## **CASE REFERENCE: JP14.318314**

**RESPONSE TO:                      REQUEST FOR FURTHER INFORMATION**

Title:                                  Noise Impact Assessment

Development Address: Lanesborough, North Commons, Co Longford

Figure 8: Graphical representation of the measured 1/3<sup>rd</sup> octave dB L<sub>eq</sub> and dB L<sub>90</sub> values for each measurement. This data is included in tabular format in Appendix A.

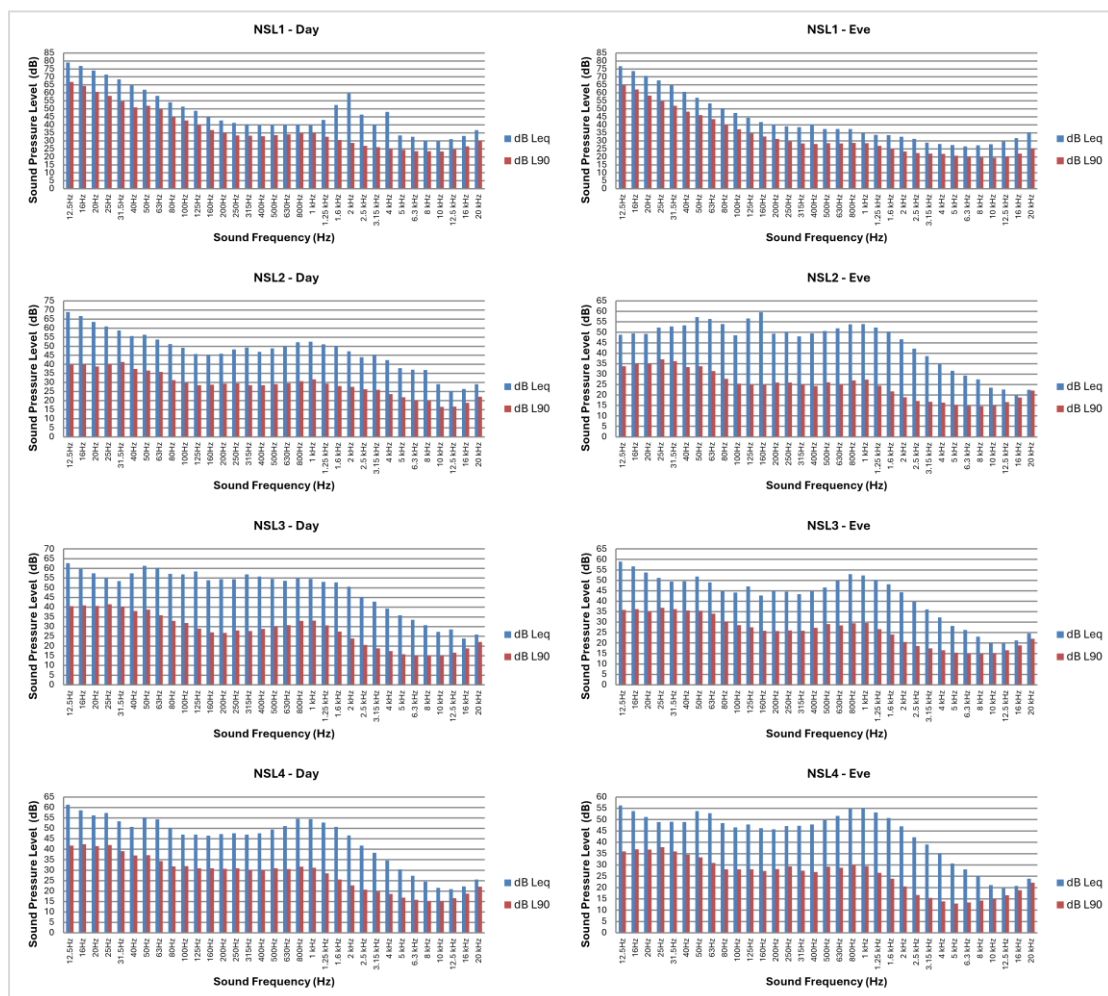
3.6
<p><b>Observation:</b> <i>"The background level noise survey for this project (Allegro Acoustics) was carried out during the highest level (level 5) of Covid-19 social and travel restrictions (April 8<sup>th</sup> and April 9 2021). As such, the baseline noise levels in the area have increased very significantly to now normal levels, since Covid-19 related travel restrictions have been removed.</i></p> <p><b>Basis for objection:</b></p> <ul style="list-style-type: none"> <li>- <i>The noise survey does not reflect normal noise levels as it was carried out during the highest (level 5) covid 19 social and travel restrictions. This caveat is included on page 8 of the report."</i></li> </ul>

The results of the noise survey are presented in Table 9 and Figure 8 below. A detailed table of results showing the measured  $1/3^{\text{rd}}$  octave dB  $L_{\text{eq}}$  and dB  $L_{90}$  values for each measurement are also included in Appendix A. Note that the background noise level is typically depicted using the dB  $L_{A90}$  statistical indicator [4].
